**ADDENDUM NO. 1**

RE: Indiana University  
Bloomington BL053 -  
IMU Biddle Hotel –  
Data Upgrades

PROJECT No. 20222853

DATE: May 28, 2024

FOURTH FLOOR ELECTRICAL PLAN

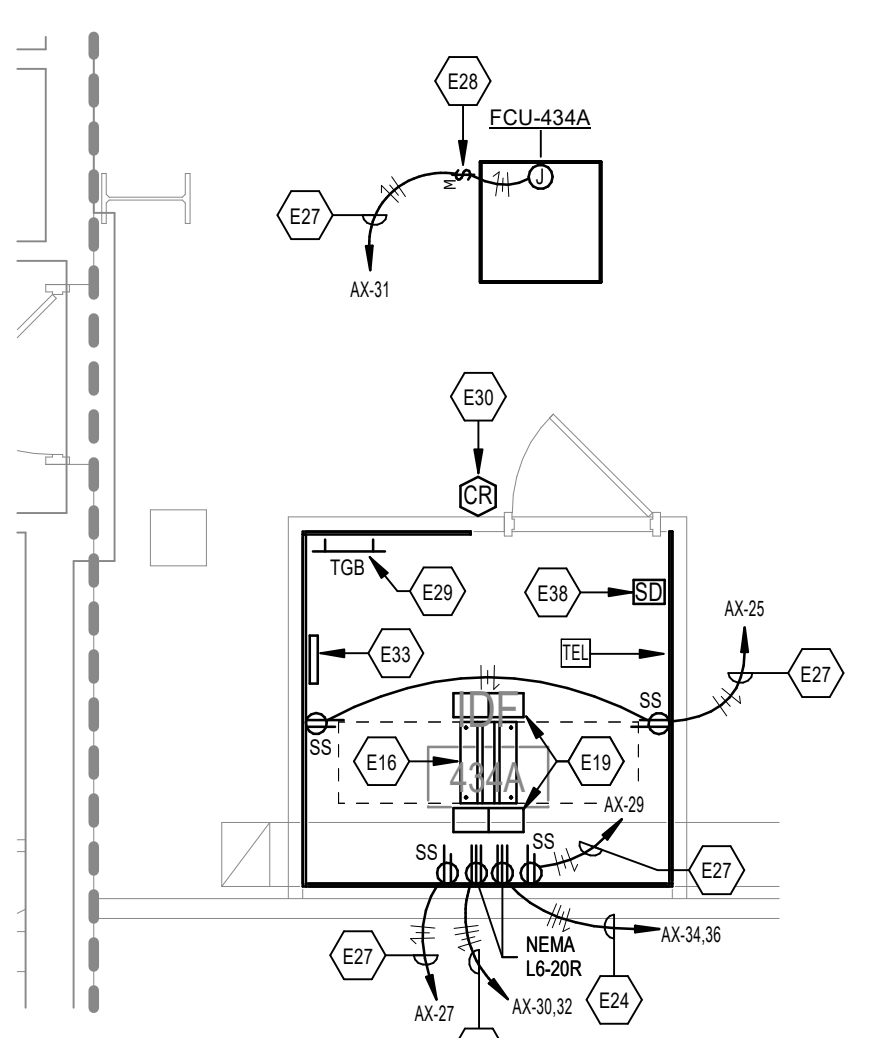
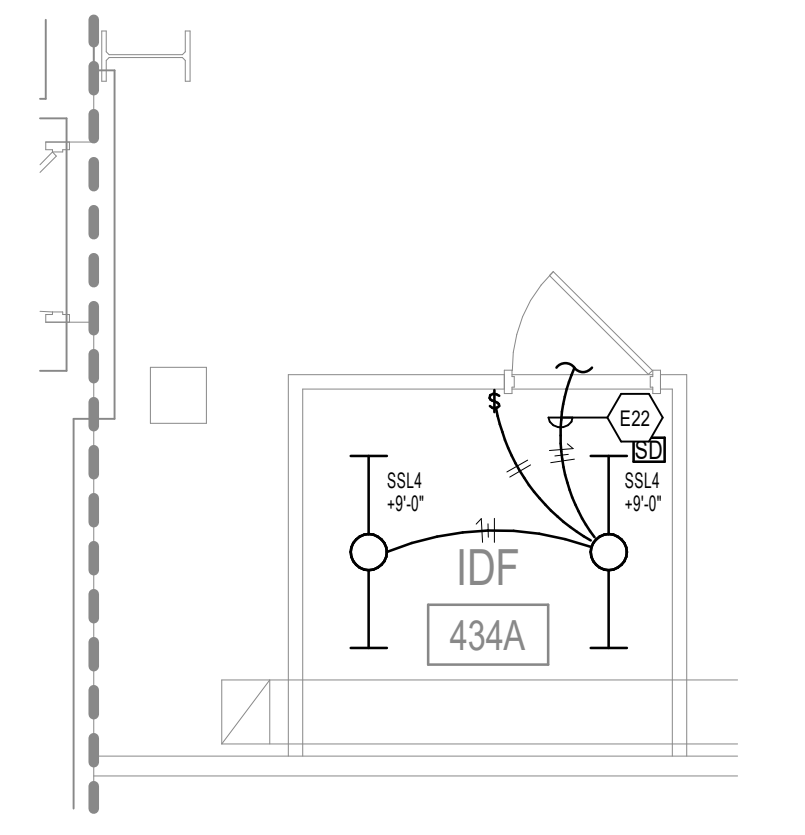
7. Sheet E204 – FOURTH FLOOR ELECTRICAL PLAN
  - a. Revised tagged notes #E12, #E14, #E17, and #E30.
8. Sheet E205 – FIFTH AND SIXTH FLOOR ELECTRICAL PLAN

- E12 CONTINUATION OF PROPOSED CONDUIT ROUTES FOR NEW GROUNDING, FIBER, AND DATA CABLING CONNECTIONS UP TO OTHER FLOORS. SEE FLOOR PLANS FOR CONTINUATION AND ADDITIONAL REQUIREMENTS AND INFORMATION.

- E14 CONTRACTOR TO PROVIDE ONE (1) NEW CAT 6A CABLE FROM EXISTING/NEW IDF TO TERMINATE AT EXISTING TELECOM BACK BOX IN GUEST ROOM(S). REMOVE EXISTING FACEPLATE AND PROVIDE BRADY LABEL AT CABLE FOR OWNER'S FINAL DEVICE TERMINATIONS. SEE FLOOR PLANS FOR AREAS SERVED BY EXISTING/NEW IDF INDICATED ON THESE PLANS. UTILIZE EXISTING CONDUIT PATHWAYS AND PULL STRINGS ABOVE ACCESSIBLE CEILINGS AND IN WALLS FOR CABLE ROUTING. REFER TO DIV 27 SPECIFICATIONS FOR ADDITIONAL REQUIREMENTS AND INFORMATION.

- E17 PROVIDE TWO (2) 4" CONDUIT SLEEVES IN THIS ROOM FOR PATHWAYS UP TO AND DOWN FROM OTHER LEVELS FOR CABLE ROUTES. ON EACH FLOOR, CONDUITS TO ROUTE UP TO LAY-IN CEILING TO STUB UP ABOVE ACCESSIBLE CEILING. IF NO LAY-IN CEILING, CONDUITS TO ROUTE UP TO HEIGHT OF THROUGH WALL SLEEVES INTO ADJACENT CORRIDOR SPACES FOR CABLE ROUTING.

- E30 NEW CARD READER DEVICE. PROVIDE BACKBOX, CONDUIT PATHWAYS, AND ALL OTHER SYSTEM COMPONENTS, EQUIPMENT, AND CONNECTIONS AS REQUIRED FOR A COMPLETE AND OPERABLE SYSTEM. CARD READER TO BE CONNECTED TO NEW DOOR ACCESS CONTROLLER IN IDF 350A. PROVIDE 18/4 CABLE FROM ALL CARD READER LOCATIONS BACK TO THIS CONTROLLER. REFER TO DIVISION 08 SPECIFICATIONS FOR ADDITIONAL REQUIREMENTS AND INFORMATION.

FIFTH AND SIXTH FLOOR ELECTRICAL PLAN

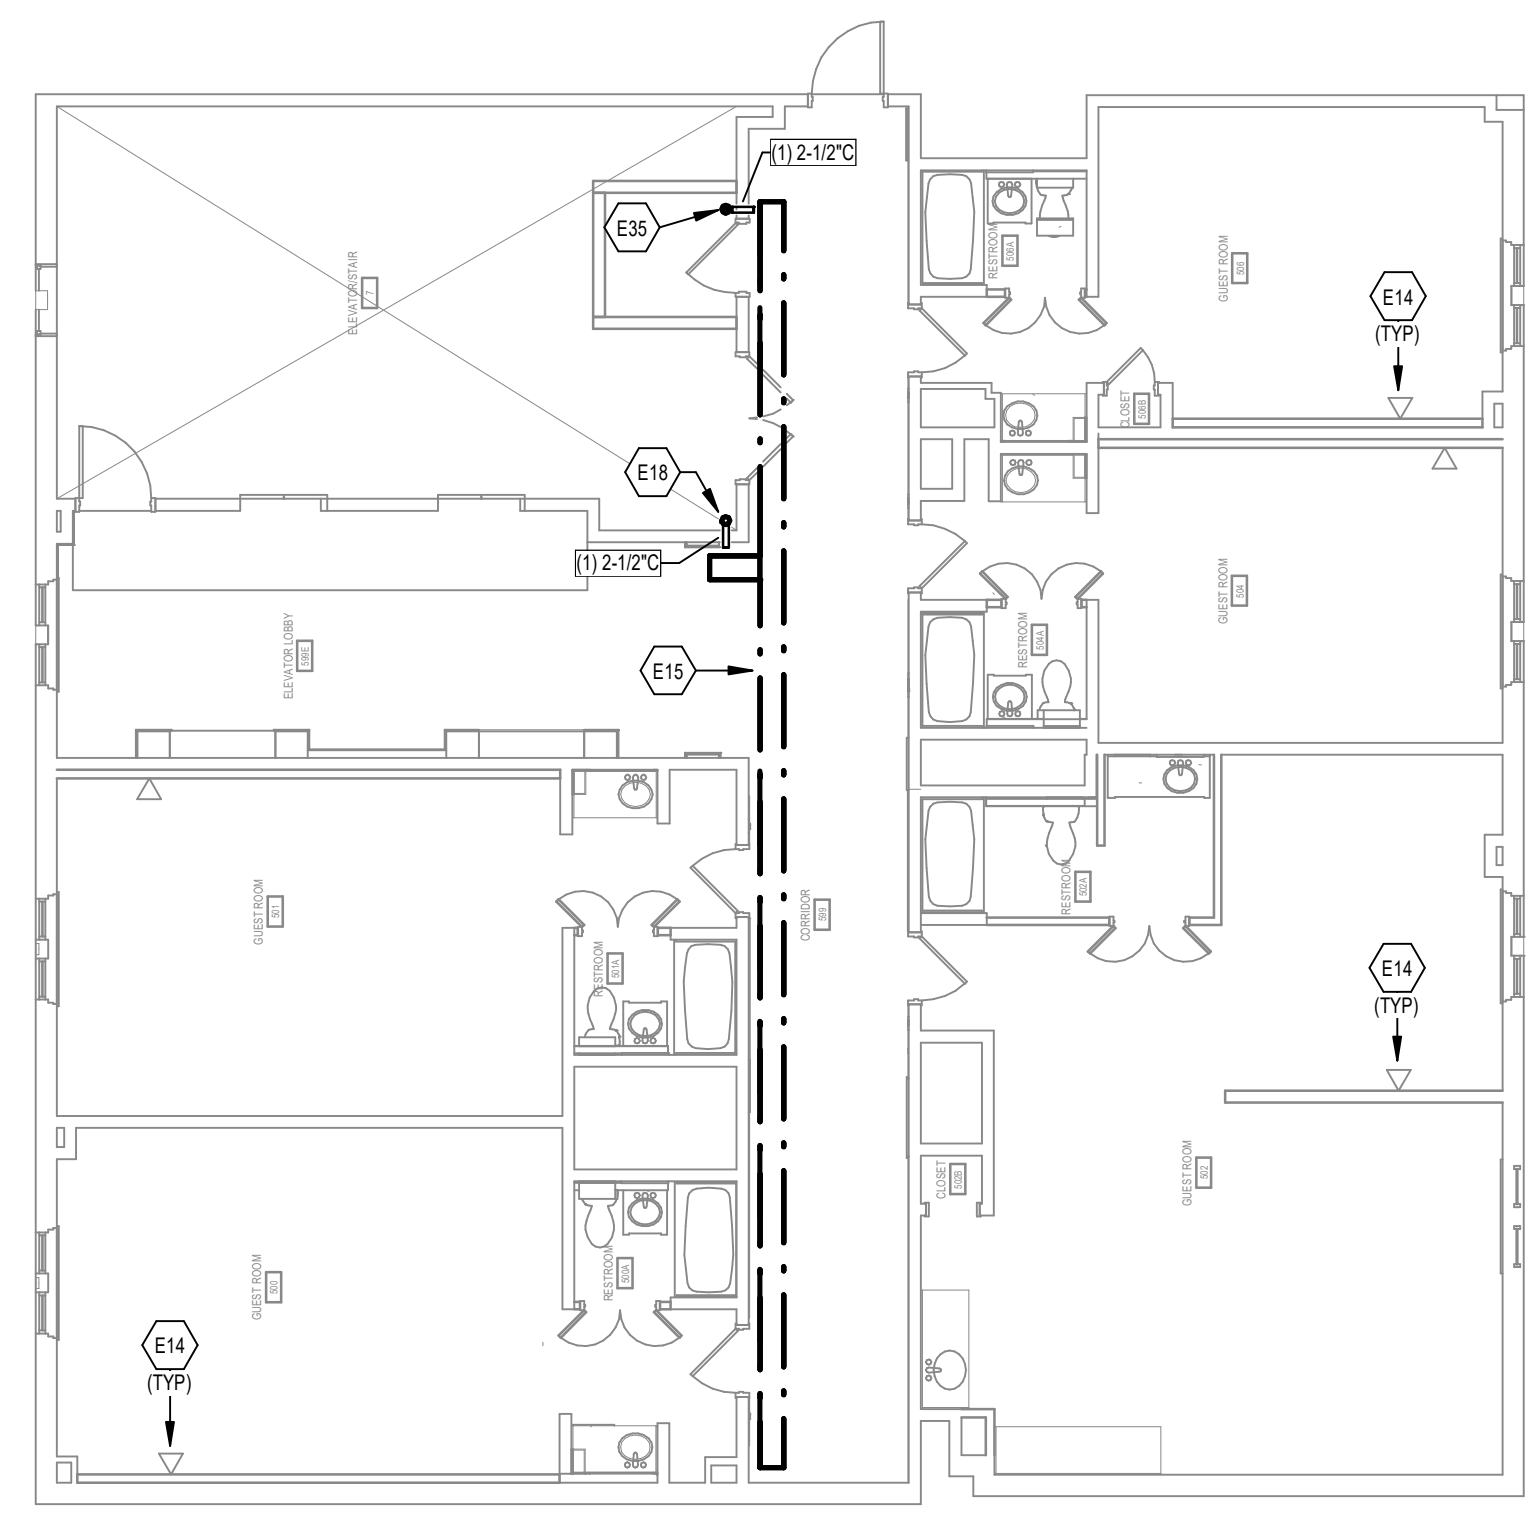
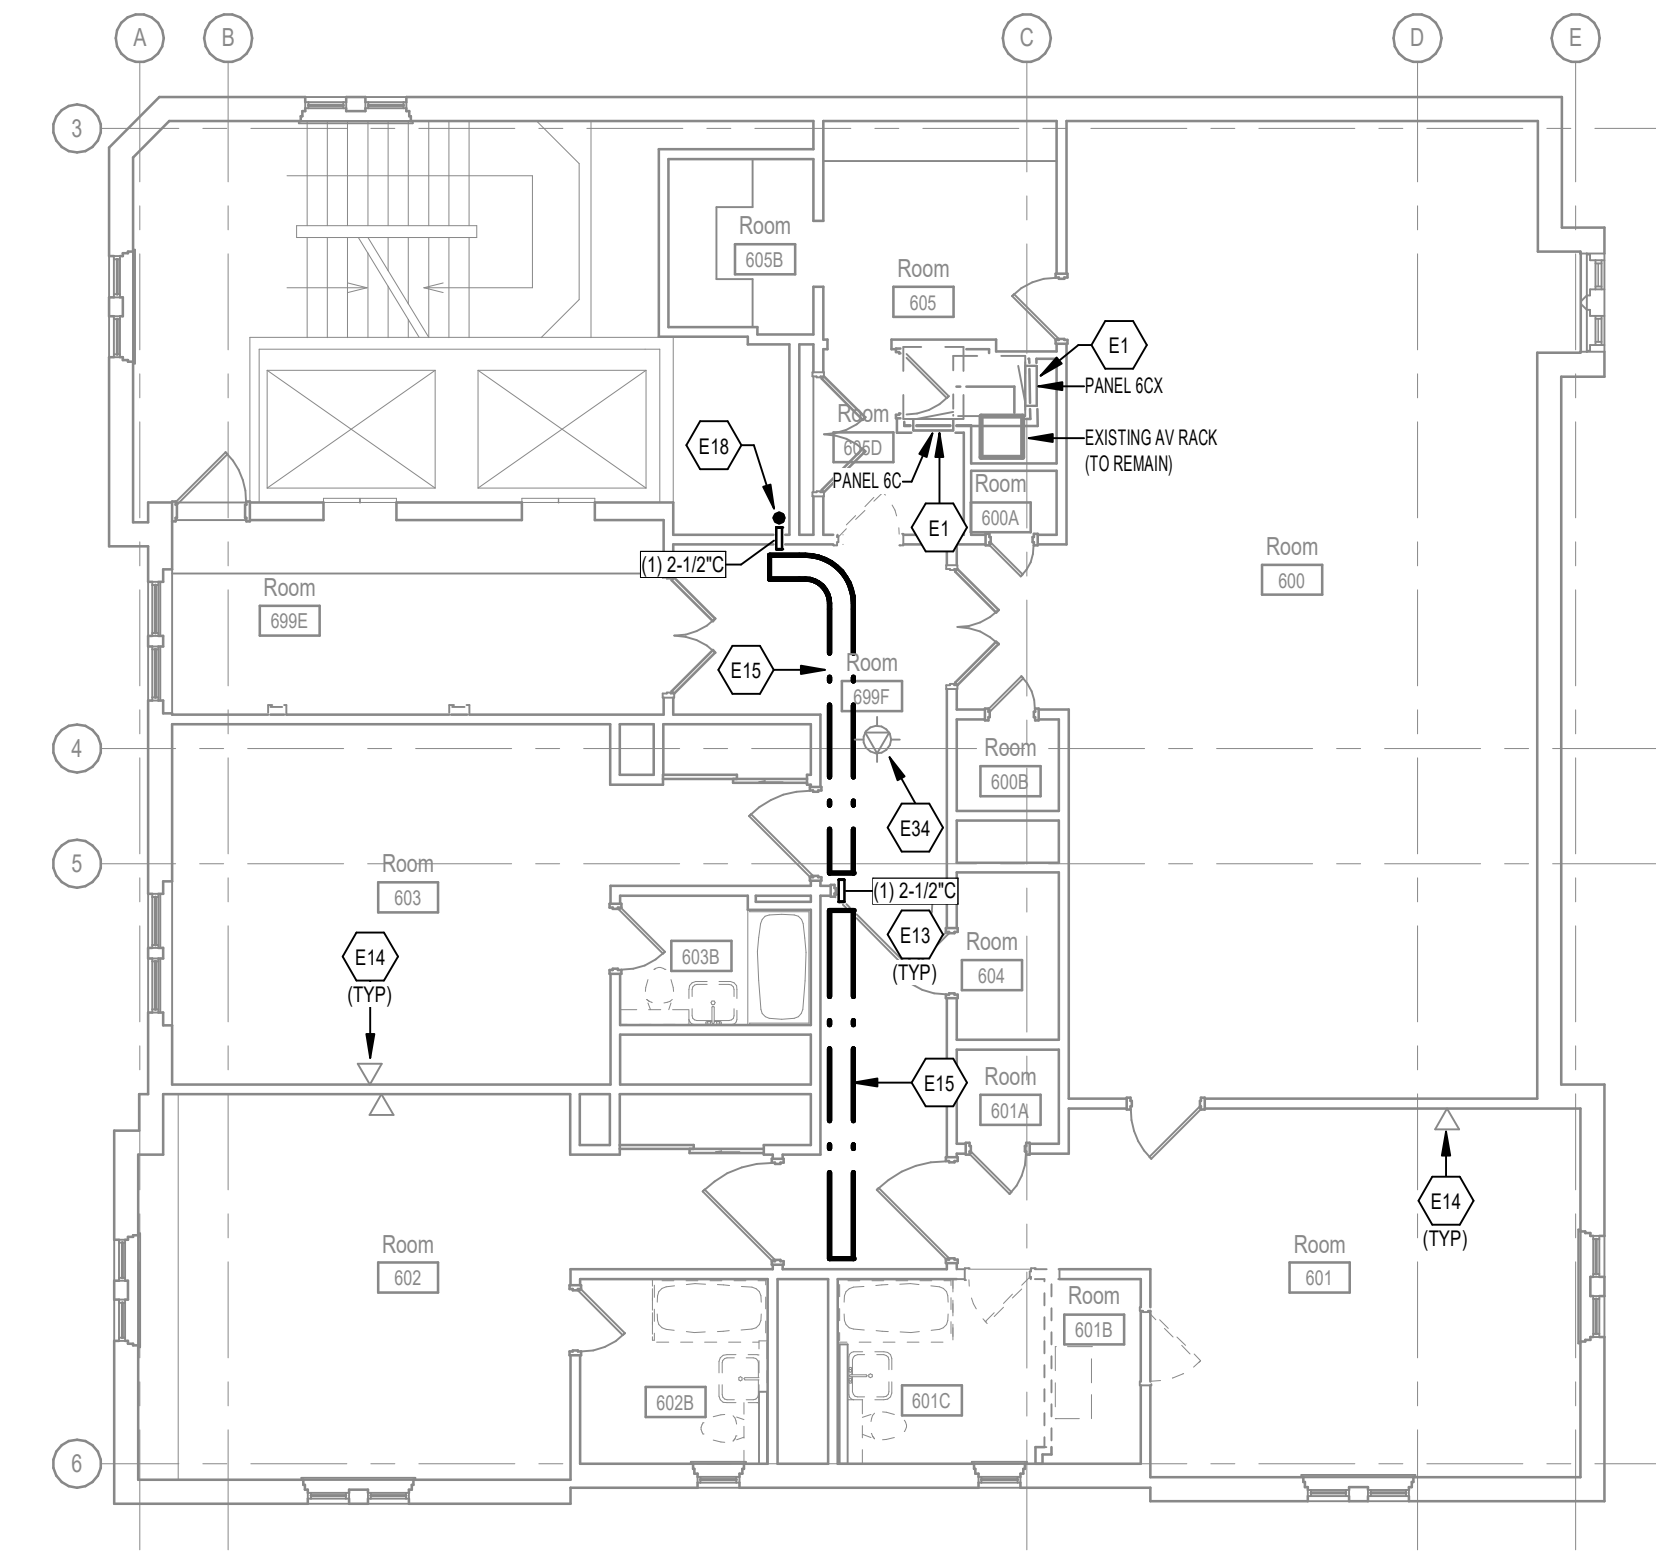
- a. Revised tagged note #E14.
9. Sheet E300 – ELECTRICAL DETAILS
  - a. Detail #1 removed. Refer to floor plans and Division 08 specifications for door access controls requirements.

- E14 CONTRACTOR TO PROVIDE ONE (1) NEW CAT 6A CABLE FROM EXISTING/NEW IDF TO TERMINATE AT EXISTING TELECOM BACK BOX IN GUEST ROOM(S). REMOVE EXISTING FACEPLATE AND PROVIDE BRADY LABEL AT CABLE FOR OWNER'S FINAL DEVICE TERMINATIONS. SEE FLOOR PLANS FOR AREAS SERVED BY EXISTING/NEW IDF INDICATED ON THESE PLANS. UTILIZE EXISTING CONDUIT PATHWAYS AND PULL STRINGS ABOVE ACCESSIBLE CEILINGS AND IN WALLS FOR CABLE ROUTING. REFER TO DIV 27 SPECIFICATIONS FOR ADDITIONAL REQUIREMENTS AND INFORMATION.

1 DATA DISTRIBUTION RISER  
 NO SCALE

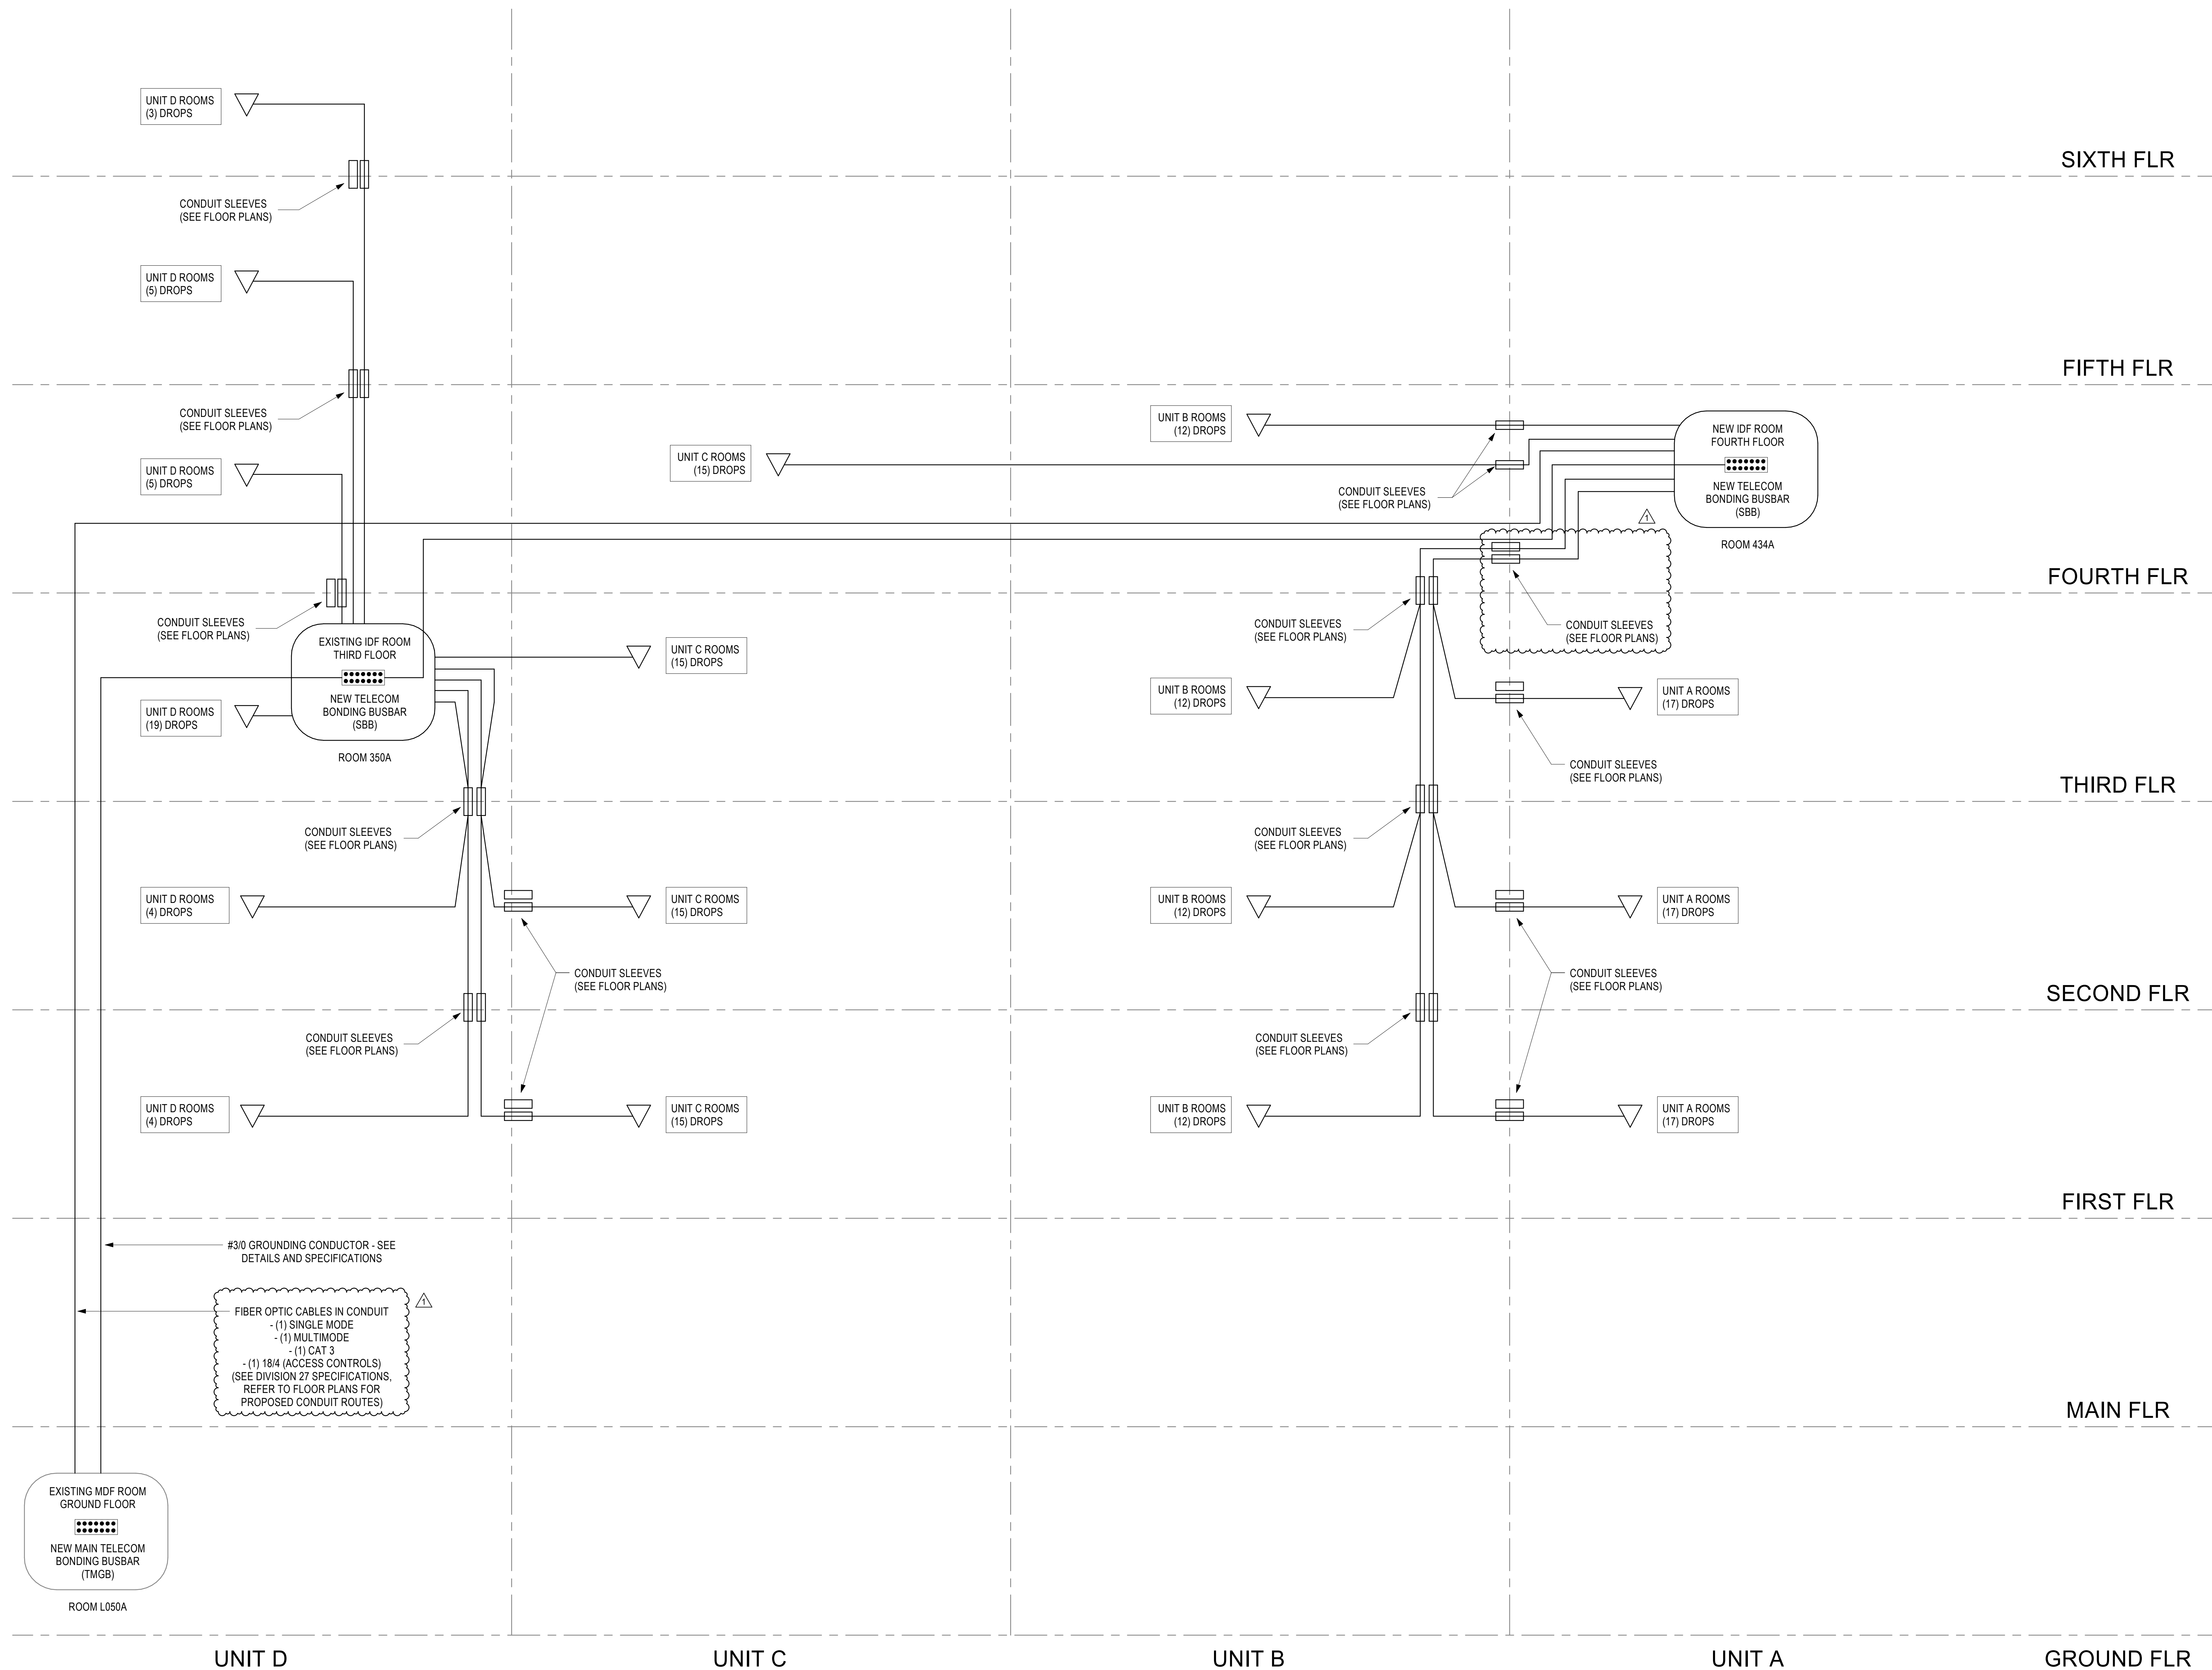
- b. Revised notes for detail #4.
10. Sheet E301 – ELECTRICAL DETAILS
  - a. Revised notes for detail #3.
11. Sheet E302 – DATA DISTRIBUTION RISER
  - a. Revised notes.
